## 1. Are there any potential highways / pedestrian safety issues not satisfactorily overcome?

### 1.1 Safety issues

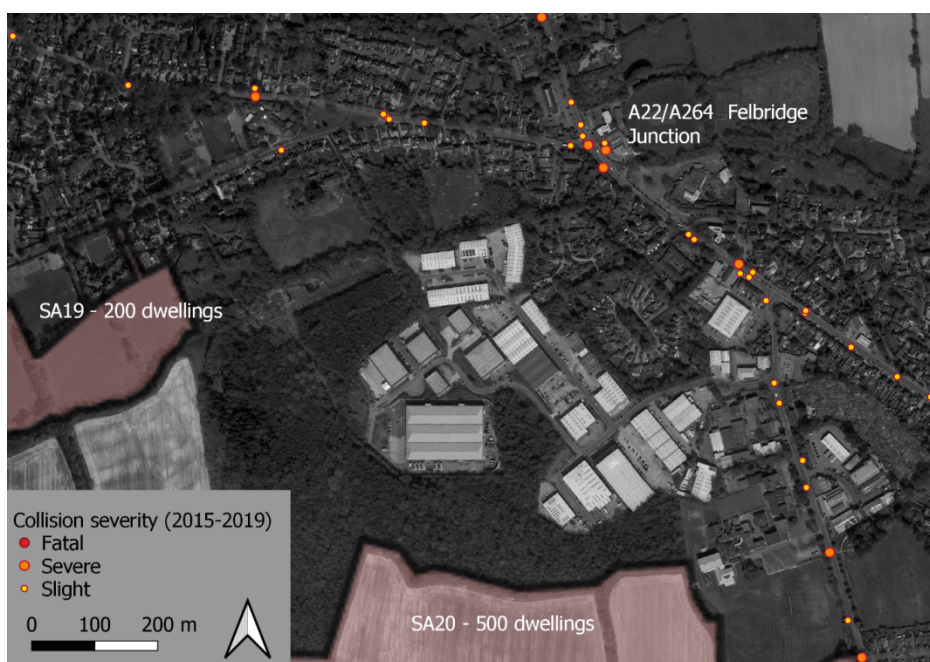
1.1.4 Firstly, the analysis uses collision data for Mid Sussex District only. In the case of junctions on the local authority boundary such as the A22/A264 Felbridge Junction, collisions georeferenced in the neighbouring authority are excluded. The following collision plot highlights the cluster of collisions around the junction. By contrast, it is standard practice when identifying collision hotspots to collate collisions around specific junctions regardless of local authority boundaries.

- 1.1.8 The A22/A264 Felbridge Junction is one junction that would qualify for further examination under the criterion of the number and severity of collisions (if collisions at the local authority boundary are included). Yet it does not meet the test of the second criterion because the congestion already occurs in the Reference Case.

- 1.1.9 For the reasons outlined above, the methodology fails to identify collision hotspots at the Felbridge Junction and on Imberhorne Lane although these two locations are existing collision hotspots and are the locations in the town that are most directly affected by site allocations SA19 and SA20.
